CHANGE ORDER

Construction for
New Start Center of Everett
1602 SE Everett Mall Way
Everett, WA 98208

CO Number: 03
Date: 13 May 2025

Prime Contract Potential Change Order #006: Added wall heater / Pressure Test

AREAS B-F - LEVEL 02 HVAC PLAN

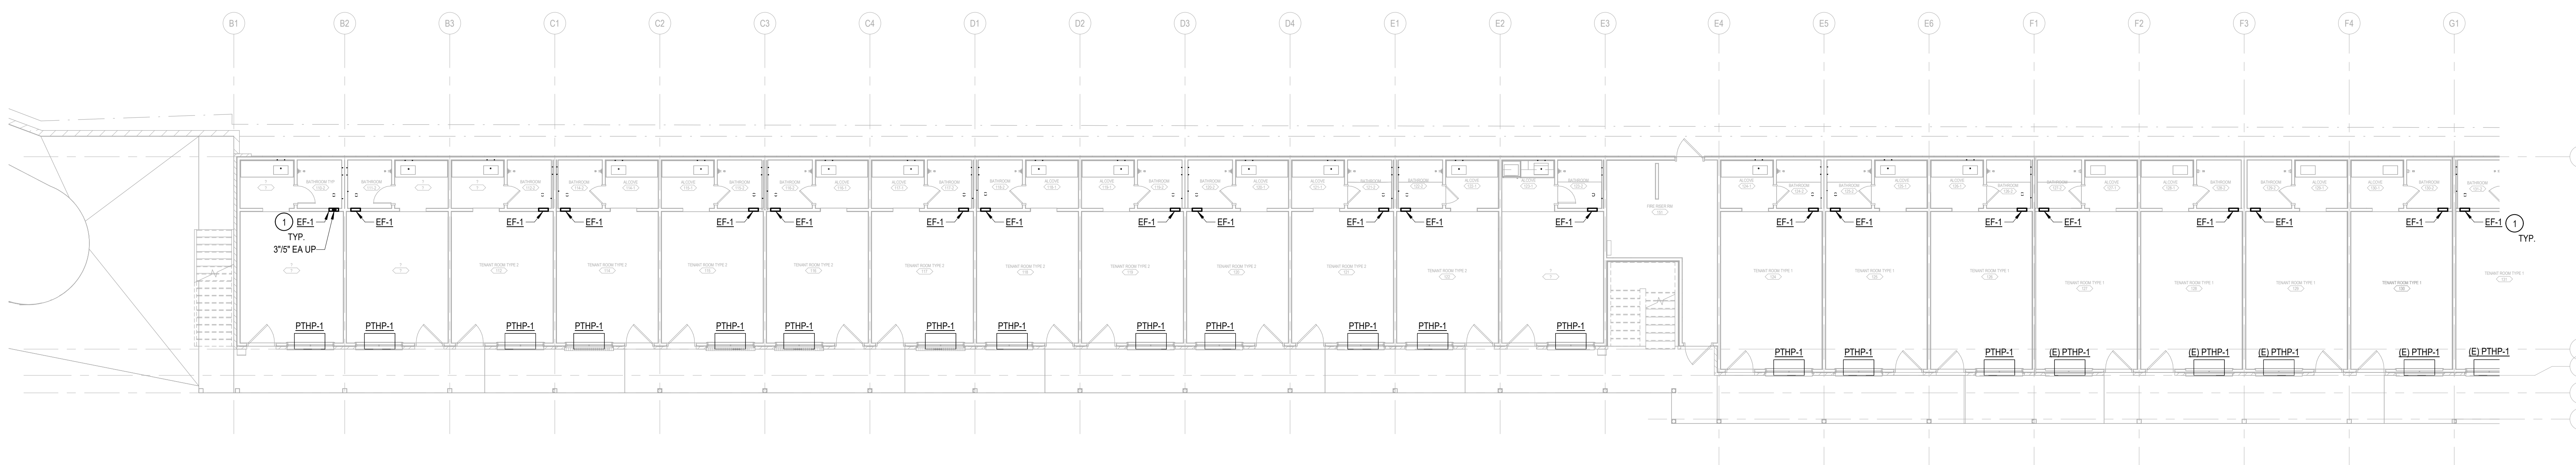
Wall units heaters not required in electrical rooms in building A. Add electric wall heater in room "251 Electrical" in Building B, Area E. Provide Qmark CWH1202DSF 750W from submittal 238239-001. Locate heater on external wall on the North side of the electrical room.
